Comment Response Sheet

DESCRIPTION		SEAL AND SIGNATURE:	
PROJECT NUMBER: 2015-109			
DATE: 10-06-2015			
DRAWN BY: EF			
APPROVED BY: R.J.P.			
SHEET NUMBER			
1	of 7

SILVERS SQUARE
 1100 5th STREET MIAMI BEACH, FLORIDA
 COVER SHEET

SECTION A
SCALE: 1/2"=1'-0"

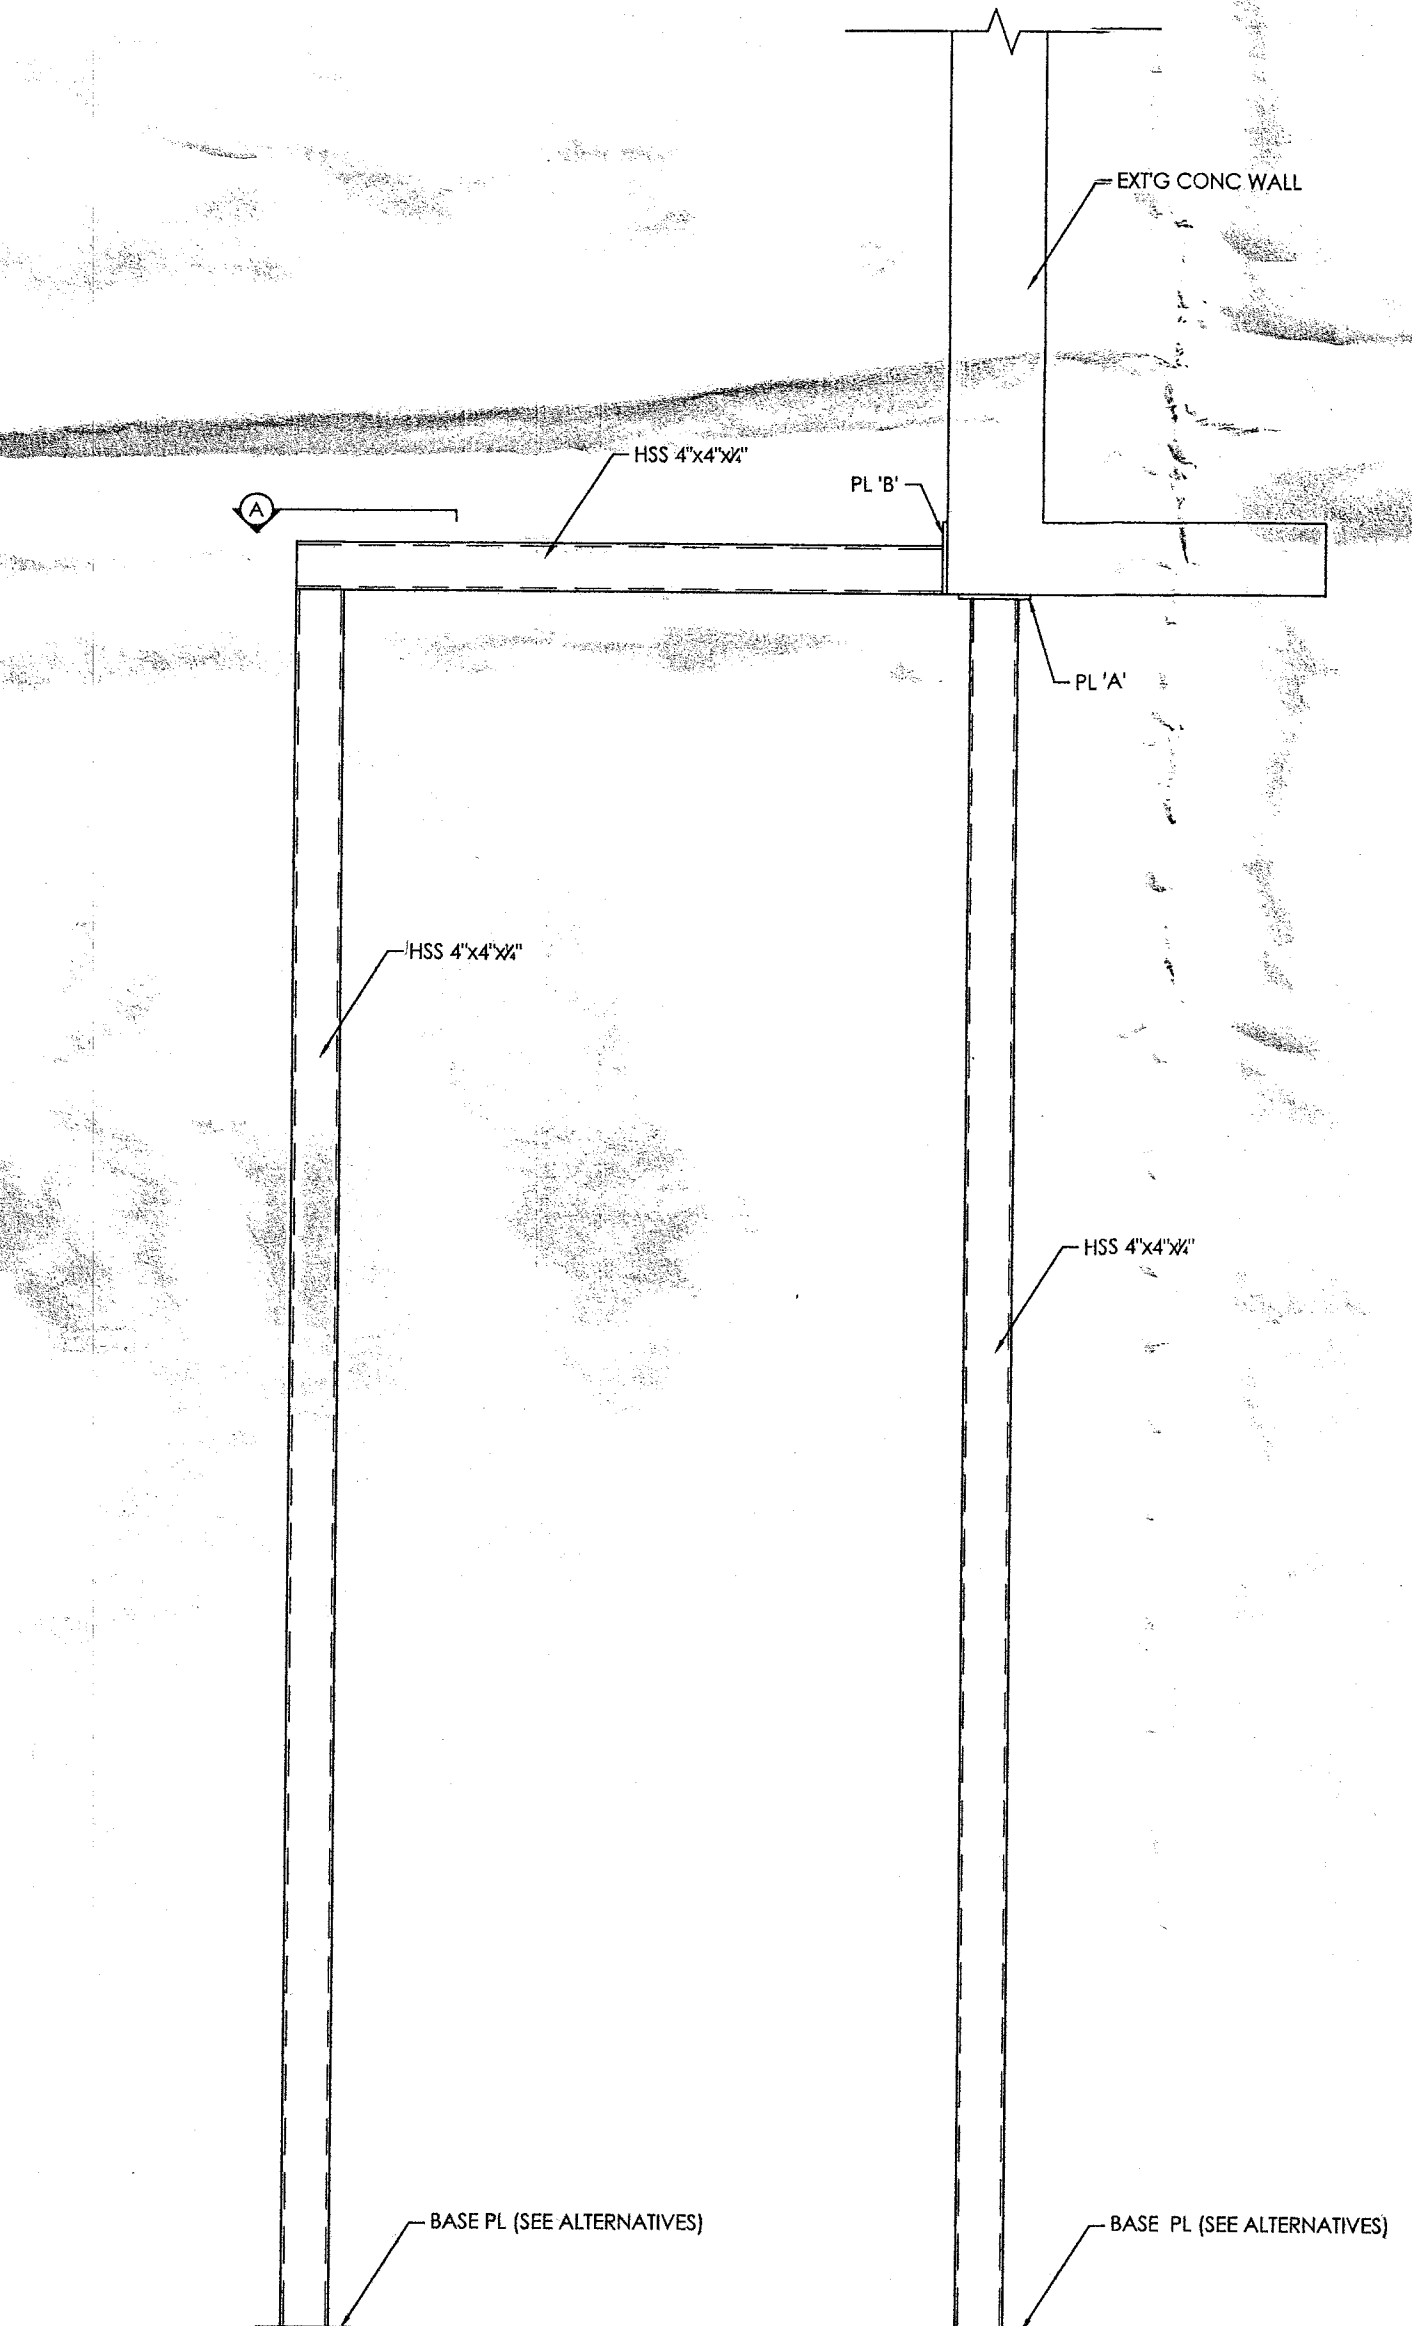
- Structural steel framing:
 - a) Provide plan view details for architectural piers of different shapes with vertical tube inside. Provide design information for framing of those piers. Provide detail for joint between those piers and the storefront jamb.

- c) Provide weld detail for joint of three members (two horizontal tubes meeting at 90 or 135 degree angles with vertical tube)
 - Please see "Weld Detail" on Sheet 2.

- There are no architectural piers. The storefront will consist of the glazing and steel framework. Plans have been updated to more accurately reflect this. Please see added "Section A" & "Angled Jamb Detail" on Sheet 2.
